### 3.4 Instrumentation and Control

The information in this section of the reference ABWR DCD, including all subsections, tables, and figures, is incorporated by reference with the following departure.

STD DEP T1 3.4-1 ([Figure 3.4a](#), [Figure 3.4b](#), [Figure 3.4c](#))

Figure 3.4a Safety System Logic and Control (SSLC) ~~Control~~ Interface Diagram

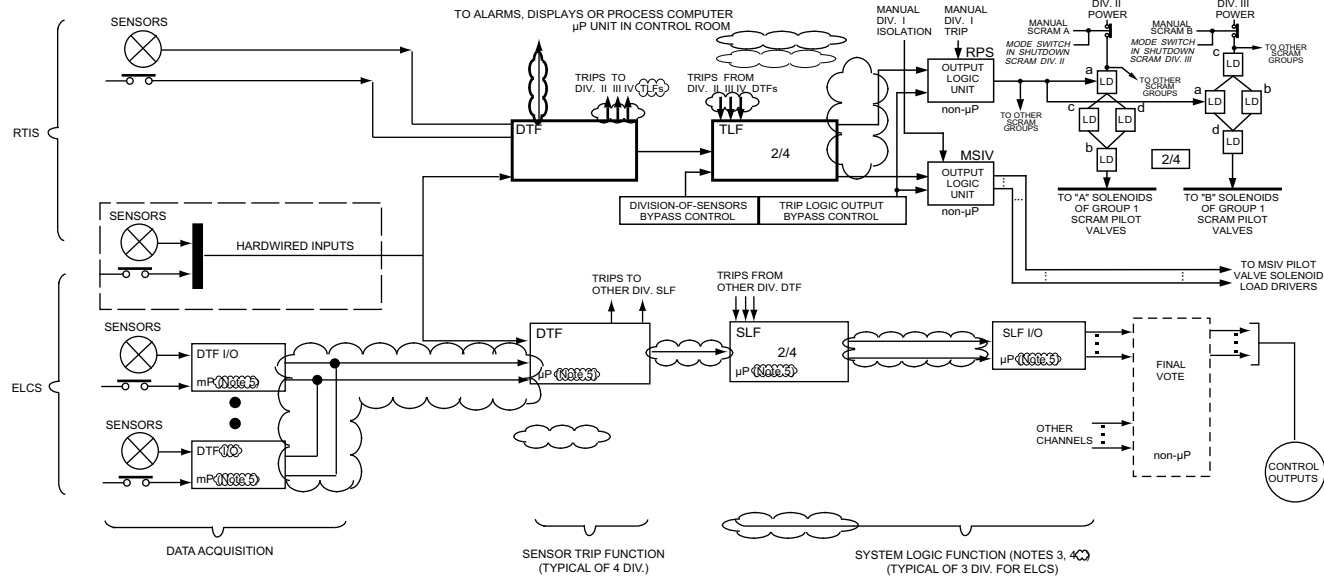
supports the accident mitigation functions. Also included in SSLC are the safety-related portions of the Neutron Monitoring System (NMS), the Containment Atmospheric Monitoring System (CAMS) and the safety-related portions of the radiation monitoring systems. *The relationship between SSLC and systems for plant protection is shown in Figure 3.4a.*

Figure 3.4b Safety System Logic & Control Block Diagram

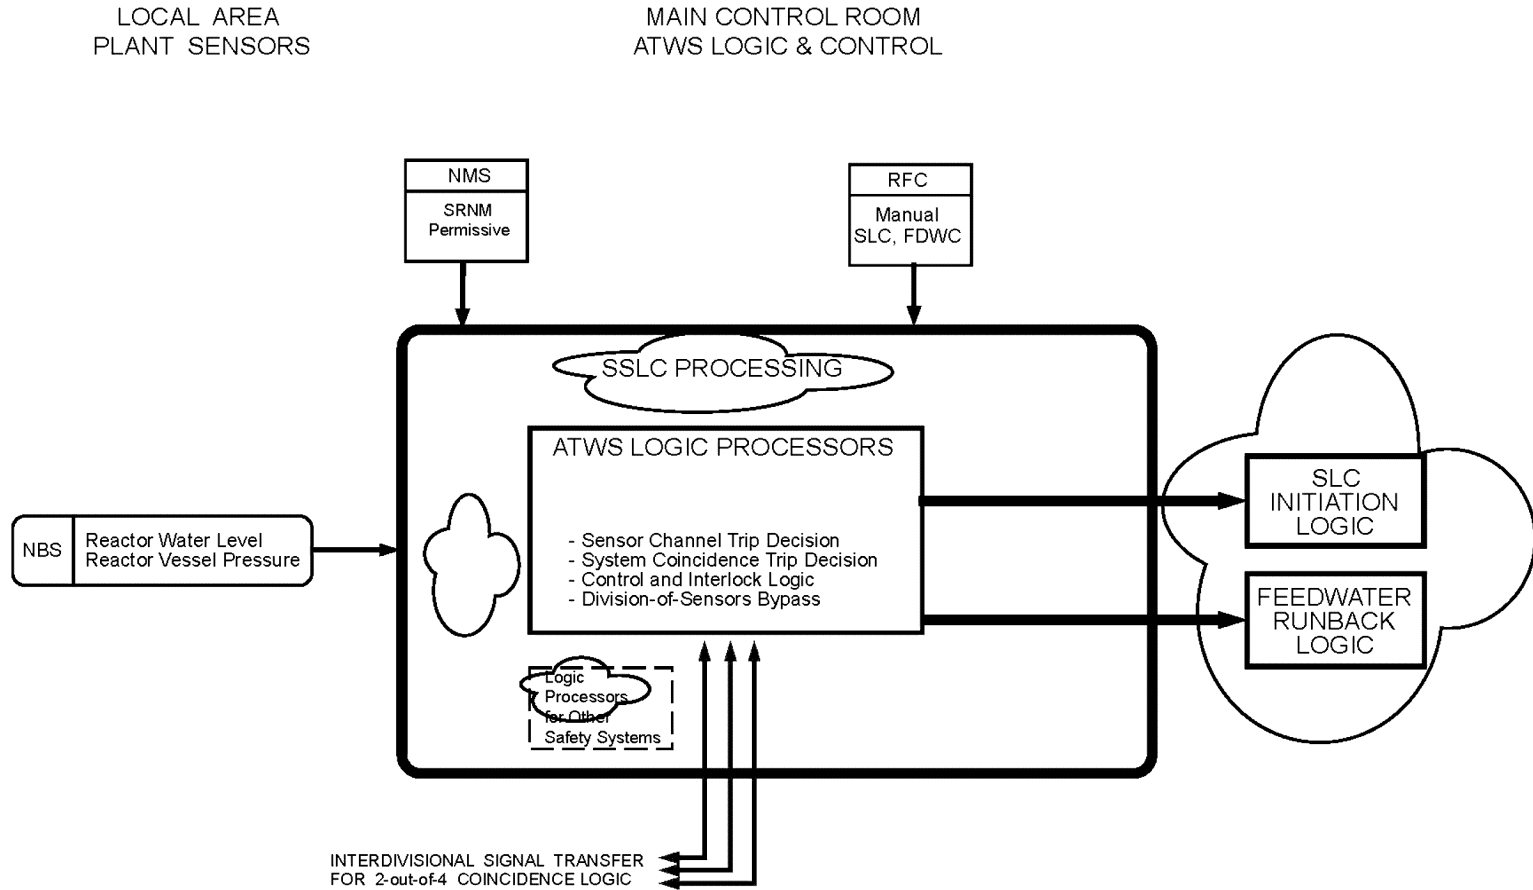
*The basic hardware functional configuration for one division of SSLC is shown in Figure 3.4b. Each division runs independently (i.e., asynchronously) with respect to the other divisions. The following steps describe the processing sequence and associated function descriptions for incoming sensor signals and outgoing control signals. These steps are performed simultaneously and independently in each of the four divisions:*

~~As shown in Figure 3.4b, a pair of SLU are located in each of two engineered safety feature (ESF) processing channels, ESF1 and ESF2. ESF1 processes initiation logic for functions which service the reactor vessel at low pressure (e.g. RHR), while ESF2 provides the same support for the vessel at high pressure (e.g. Reactor Core Isolation Cooling (RCIC) System and High Pressure Core Flooder (HPCF) System). Associated LDS and ESF functions are also allocated to these logic channels.~~

- ALL SOLID LINE CONNECTIONS NOT EXPLICITLY IDENTIFIED CAN BE EITHER HARD WIRED OR FIBER OPTIC.
- SAFETY SYSTEM LOGIC FUNCTION (SLF) FOR ECCS FUNCTIONS IS IMPLEMENTED WITH REDUNDANT CHANNELS WITH A MINIMUM 2/2 VOTE OF THE OUTPUT SIGNALS TO PREVENT INADVERTENT COOLANT INJECTION OR DEPRESSURIZATION DUE TO SINGLE SLF ELECTRONICS FAILURE. THE OUTPUT VOTE MAY BE ACCOMPLISHED EITHER BY DIRECT VOTE OF SLF OUTPUT SIGNALS OR BY A SYSTEM VOTE WHERE BOTH VALVE AND PUMP ACTUATION IS REQUIRED TO INITIATE SYSTEM ACTION. BYPASS OF A FAILED SLF CHANNEL MAY BE PROVIDED AS LONG AS THE REMAINING OPERATIONAL CHANNELS PROVIDE A MINIMUM OF TWO SLF CHANNELS FOR ECCS FUNCTIONS.**

- SAFETY SYSTEM LOGIC FUNCTION (SLF) FOR SOME ISOLATION AND SUPPORTING ESF FUNCTIONS MAY BE IMPLEMENTED WITH REDUNDANT CHANNELS WITH A NORMAL MINIMUM 2/2 VOTE OF THE OUTPUT SIGNALS WHERE INADVERTENT ACTUATION OF THE FUNCTION MIGHT REQUIRE UNREASONABLY SHORT REPAIR TIMES TO ELIMINATE OPERATIONAL IMPACT. FOR THESE FUNCTIONS, OPERATIONAL CONTROLLED BYPASS TO ALLOW OPERATION WITH A FINAL 1/1 VOTE IS PERMITTED.**
